Technical design note

Project name	Barnsley Road, Goldthorpe		
Design note title	Response to EA Comments		
Document reference	23451-HYD-XX-XX-TN-WENV-0002		
Author	Connor Henderson BEng (Hons)		
Reviewer/Approver	Rana Alidad		
Revision	P01		
Date	21 January 2025	Approved	✓

Figure 1: Baseline Scenario Fill and Drain Times

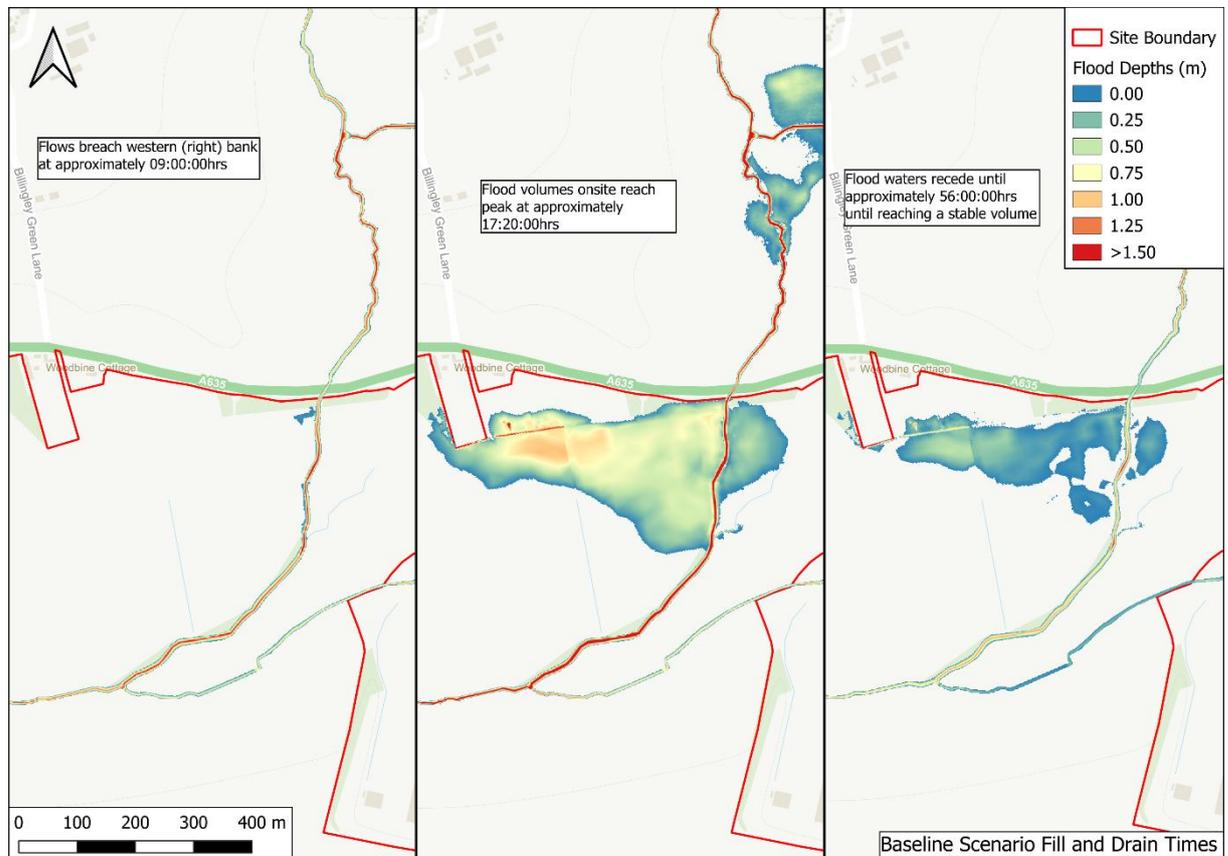
1. Fill and drain times of the proposed eastern Flood Conveyance Area (FCA) and the western Flood Storage Area (FSA) in comparison with the baseline scenario
2. Larger scale maps depicting the results of blockage sensitivity testing on flood extents
3. Further detail on the management and maintenance plan for the proposed culverts linking the proposed Flood Storage Areas.

During the baseline scenario, the primary flood mechanism affecting the site is high flows exceeding the capacity of the channel, in particular at locations where bank levels are lower than surrounding levels. As depicted in Figure 1 below, flows are predicted to spill out of the western (right) bank of the Carr Dike in the north of the site at approximately 09:00:00 hours into the flood event. flows then expand across the site to the west, with the eastern (left) bank being breached approximately 12:40:00 hours into the flood event. At

approximately 17:20:00 hours into the event, the floodplain volume onsite reaches its peak, following which flood waters recede back into the Carr Dyke until approximately 56:00:00 hours into the event.
